## Application for Design Review

**Name(s) of Applicant:** Little Miami Brewing Co - Dan Lynch  
"LMBC Rooftop Canopy/Awning & Sun Shades"

Little Miami Brewing Company – 208 Mill Street, 1. Rooftop Beer dispensing station covered by a 10X20 Canopy  
2. 3 Sunshades over customer seating area on rooftop, 3. approx 1500 sq ft paver patio with sitting wall for  
riverview area

Project: **Re: 208 Mill Road, Milford, OH – Engineering Change submission**

**ROOF FRAMING**

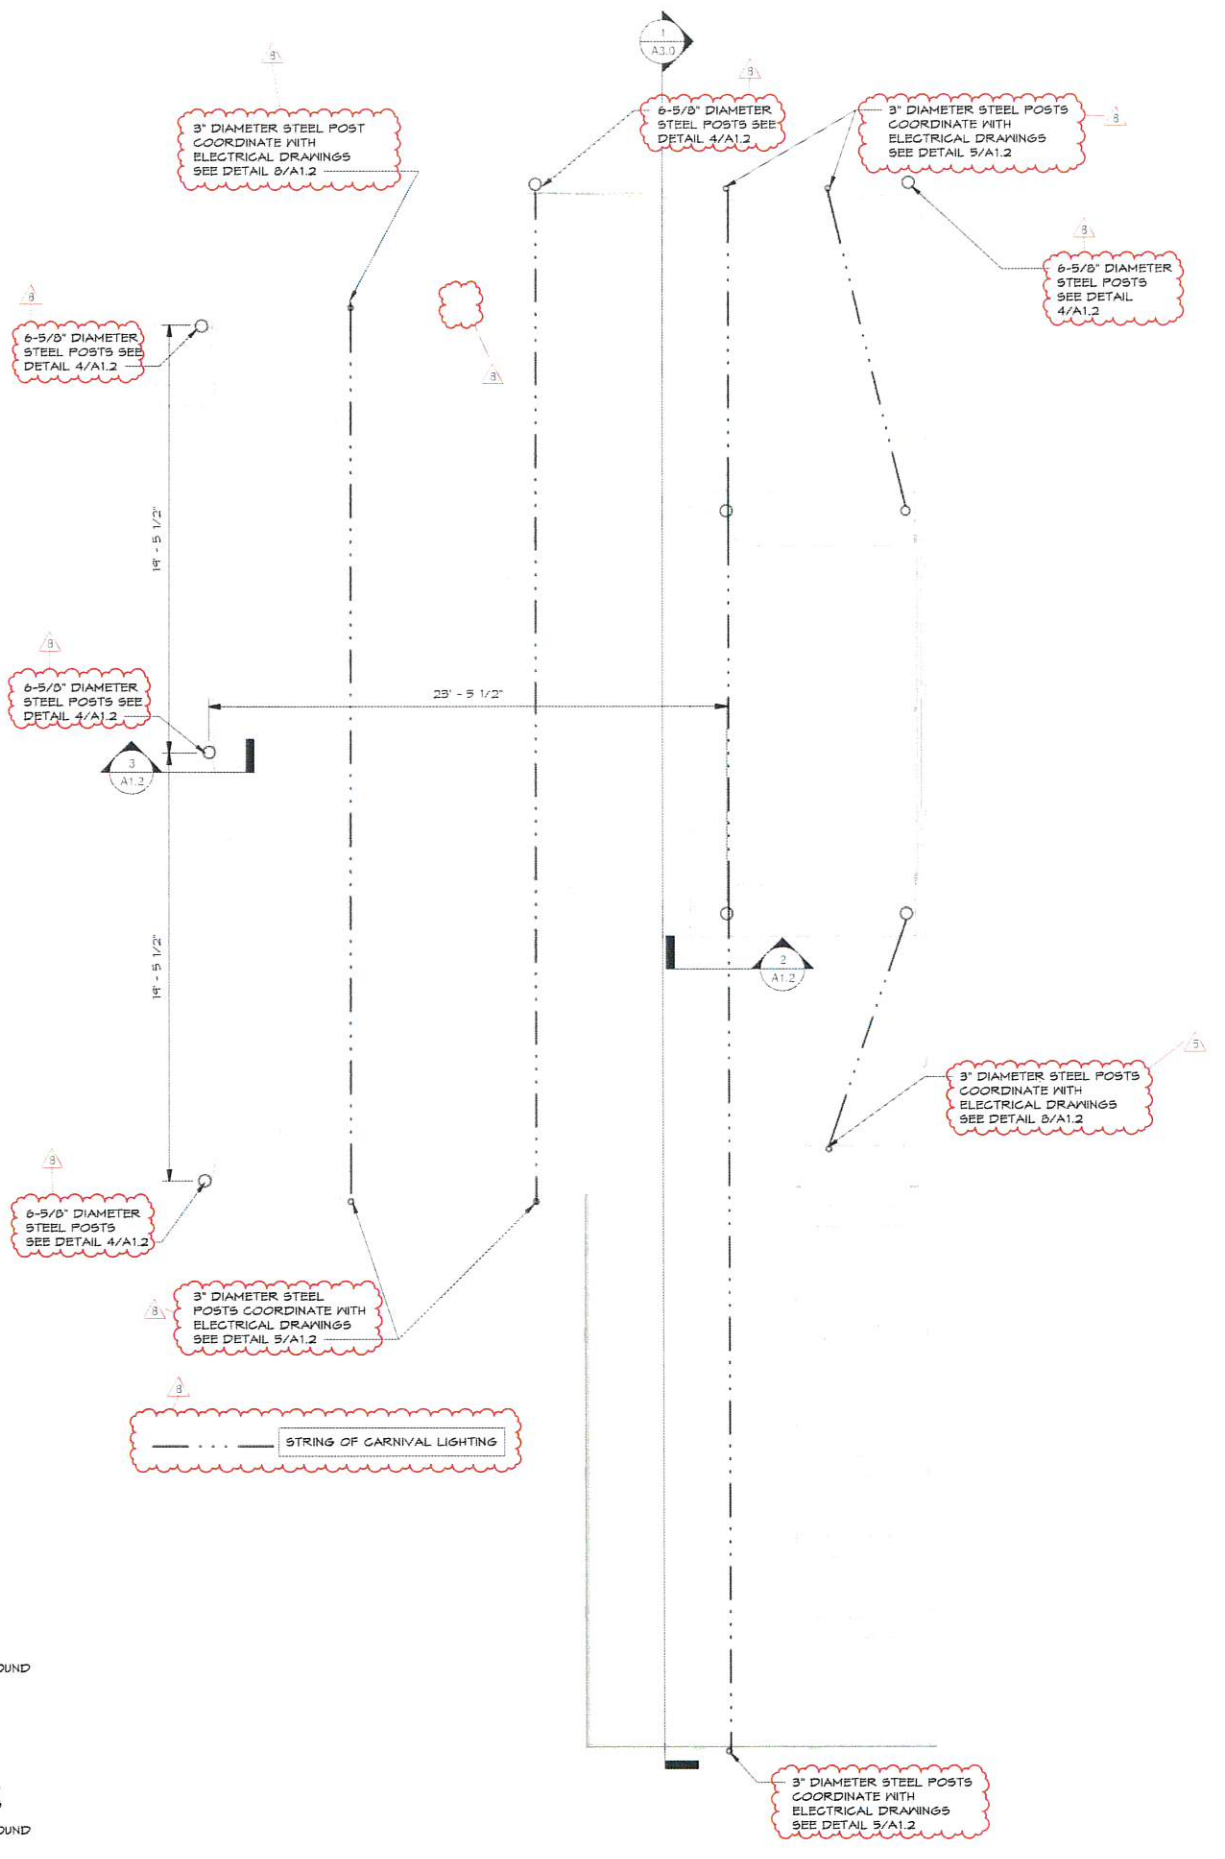
These revised drawings are being resubmitted as an engineering change to the above listed project. The reason for the engineering change is based upon adding 3 sunshades to the roof top area. The sunshades required additional steel to support the loads created by installing the sunshades. The sunshades will not be installed year-round and will be removed during the winter months. In addition to the sunshades, a small satellite bar has been added to the rooftop.

The drawing revisions related to the sunshades and satellite bar installation are bubbled and tagged with a triangle 6.
